SITE/PROJECT: **A59 KEX GILL DIVERSION**

TITLE: **Soft Landscape: Planting Plan (Sheet 12 of 15)**

SCALE @ A1: 1:500	CHECKED: SF	APPROVED: AW
PROJECT NO: 70049554	DESIGNED: SF	DATE: 21/08/2023
DRAWING NO: <b>NYKGDD-WSP-ELS-SG-DR-LE-00022</b>		REV: <b>C03</b>

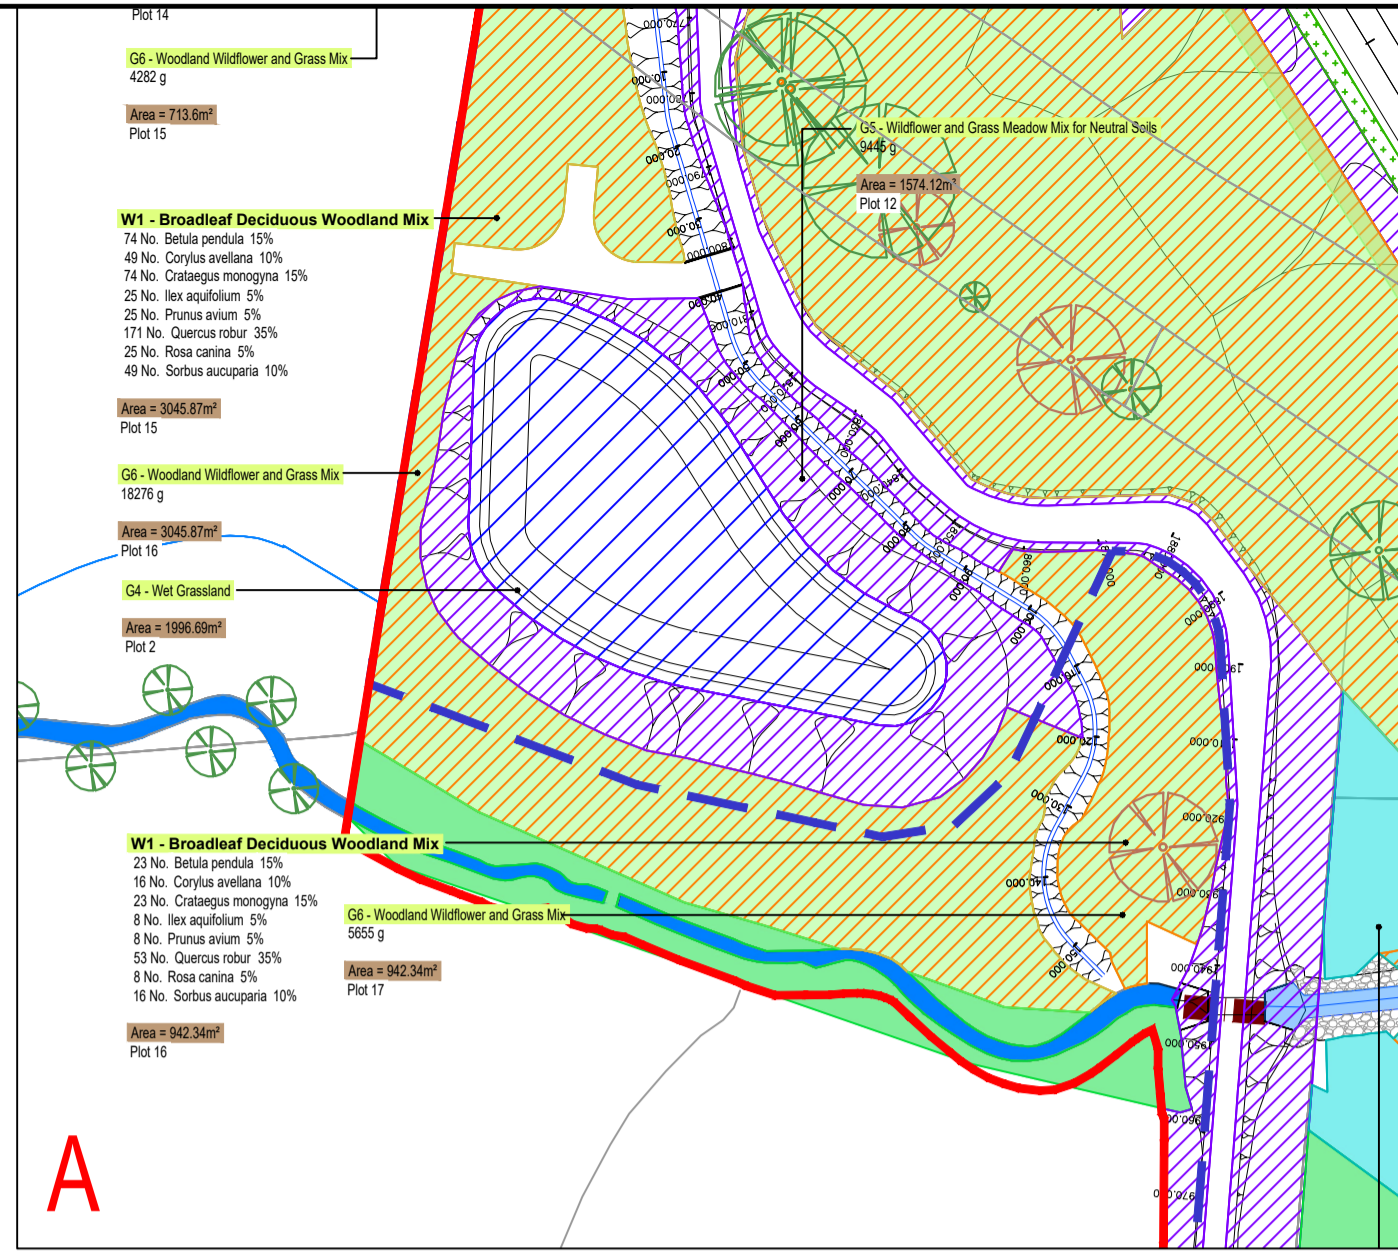
**NOTE - CONSTRUCTION ISSUE C03**

- Amendments to the design at Church Hill (minor amendments to the boundary treatments to allow for the road reconfiguration, and gates altered at church car park);

- Amendments to the design at Hall Lane (minor amendments to the boundary treatments to allow for the road reconfiguration);
- Division of Hall Beck (alteration to watercourse alignment and design);

- Soft landscaping around drainage areas including Attenuation Ponds (refer to Point 6);
- Siting of interceptor channels and filter drains (soft landscaping around changes in Point 3);

- Variation in slope angle on certain sections (change in type of planting in certain areas due to underlying geotechnical feature placement associated with soil stability);

- Inclusion of reinstatement works for areas used as temporary construction compounds;
- Areas of woodland and scrub planting are to be reconfigured, following recent tree clearances; and

- No. 8 additional tree guards will be provided within livestock fields near Blubberhouses Hall to protect growing trees.
